## RESPONSE TO REQUEST FOR ADDITIONAL INFORMATION

### APR1400 Design Certification

RAI No.: 244-8326  
SRP Section: 09.03.03 – Equipment and Floor Drainage Systems  
Application Section:  
Date of RAI Issue: 10/14/2015

### **Question No. 09.03.03-4**

Figure. Turbine Generator Building Drain System

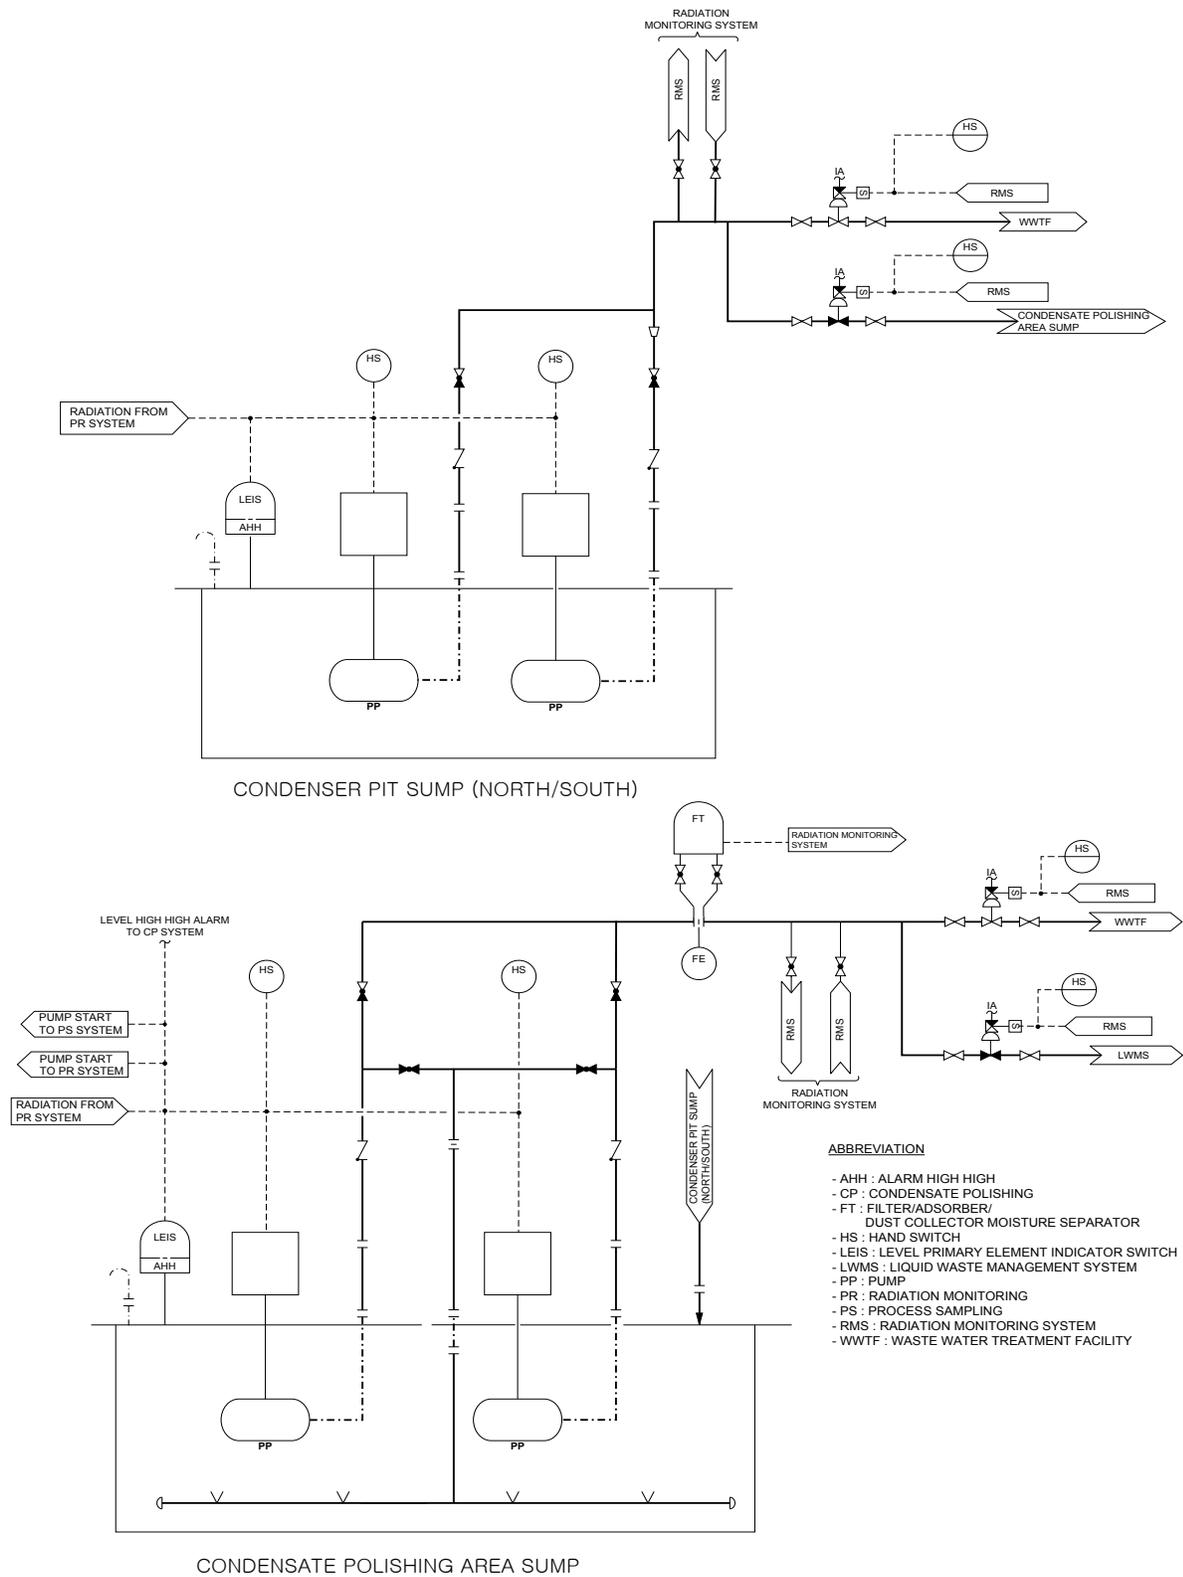
DCD Tier 2, Section 9.3.3.2.2, states that the turbine generating building sump radiation monitors are interlocked with the sump discharge valves to provide proper routing of contaminated fluid. However, the staff is unable to fully determine the operation and circumstances of sump discharge valve operation and thus cannot determine whether the design meets GDC 60 to control suitable releases of radioactive effluents.

The applicant is requested to provide additional information as to how these valves change the flow path in order to conclude whether this is an automatic function or operator action is required.

The turbine generator building drain system consists of condenser pit sumps (north/south) and a condensate polishing area sump. The below figure shows the interconnection of the turbine generator building drain system between the liquid waste management system (LWMS) and the waste water treatment facility (WWTF).

All sump pumps discharge into the WWTF as long as no contamination fluid is present. The discharge from the condensate polishing area sump is monitored for process radiation. Upon detection of radioactivity, the operating sump pump is stopped automatically by the RMS signal. The discharge valve to WWTF is closed, and the discharge valve to LWMS is opened simultaneously. Then, the sump pump is manually started. The flow is then diverted to the LWMS.

The discharges from the condenser pit sumps are monitored for process radiation. Upon detection of radioactivity, the operating sump pumps are stopped automatically by the RMS signal. The discharge valve to the WWTF is closed, and the discharge valve to condensate polishing area sump is opened simultaneously. Then, the sump pump is manually started. The flow is then diverted to the LWMS.

The DCD will be revised to state that the COL applicant is to provide the flow diagram of turbine generator building drain system.
